*Berden Parish Council
Martins Green
Berden
Bishops Stortford
CM23 1AE*

Re: Planning Application Reference: UTT/21/2158/SCO
Proposal: Request for a Screening Opinion in relation to a proposed solar energy scheme by Statera Energy
Location: Land Adj. Pelham Substation Park Green Lane Berden

With regards to the above EIA screening request, we have the following comments.

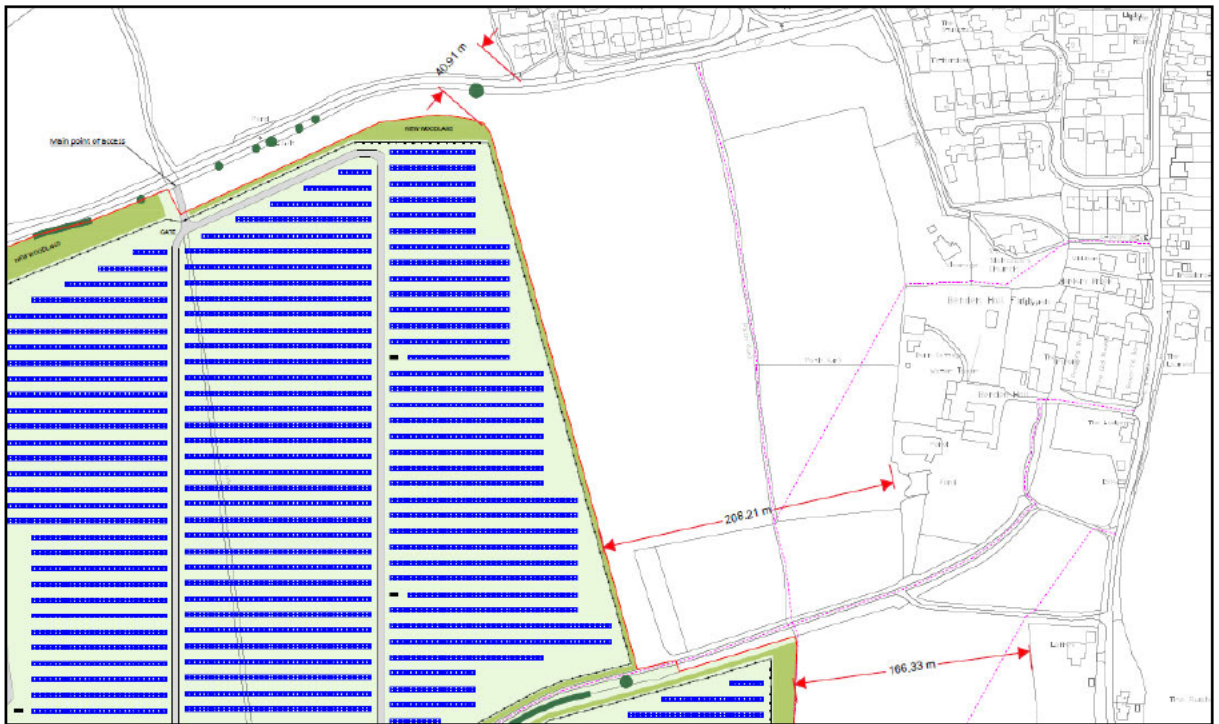
What Statera do not highlight is the wider views. The existing Statera battery units can be seen from the road to Rickling, 2 miles to the north and north east.
